IN THE DRAWINGS

Please amend FIGS. 2B, 5B, 7 and 9, as indicated on the attached marked-up copy of original FIGS. 2B, 5B, 7 and 9, to include the label “prior art.” No new matter is introduced.

REMARKS

FIG. 2B
Prior Art

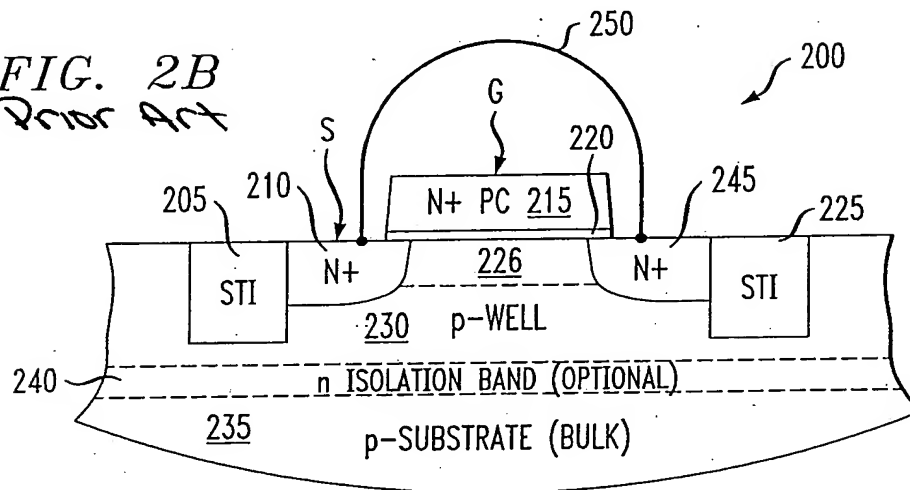
The Examiner has requested that a prior art label be added to Figures 1B, 2B, 4B, 5B, and 6-9. The Examiner has objected to the formal drawings, and requested that they be labeled as "Replacement Sheets." Applicant submits that Figs. 1A, 1B, 1C, 4A, 4B, 6 and 8 show a gated diode structure with only a gate and a source (and no drain). There are only two terminal areas for the gated diode. The present invention recognizes that this structure without the drain leads to significantly smaller gated diode physical structure (which keeps the area much smaller in applications such as memories and sense amplifiers). Thus, Figs. 1A, 1B, 1C, 4A, 4B, 6 and 8 are different from what is shown by the prior art, including Mead.

Applicants have labeled Figures 2B, 5B, 7 and 9 as "prior art" in accordance with the Examiner's suggestion and each sheet has been labeled as a "Replacement Sheet."
